TECHNICAL EVALUATION REPORT

**PRIMARY COOLANT SYSTEM
PRESSURE ISOLATION VALVES**

ARKANSAS POWER AND LIGHT COMPANY
ARKANSAS ONE UNIT 1

NRC DOCKET NO. 50-313

Figure 1. Valve Configurations Designated by the NRC To Be Included in This Technical Evaluation

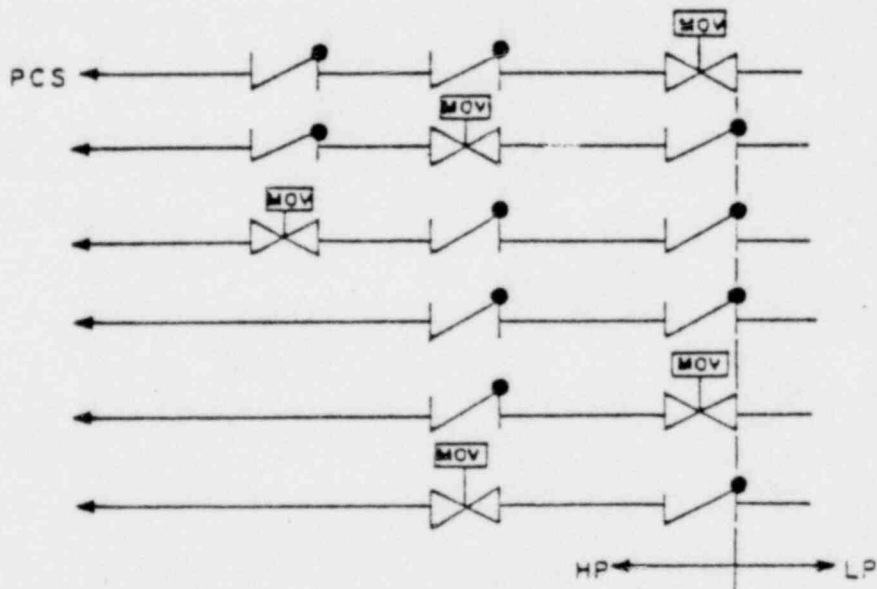
In response to NRC's generic letter [Ref. 1] the Arkansas Power and Light Company (APL) stated [Ref. 2] that, "Each low pressure injection system of ANO-1 is protected from the high pressure reactor coolant system by two check valves in series with a motor-operated valve. The configuration is represented schematically in Figure 1. These are the only Event V isolation valve configurations at ANO-1."
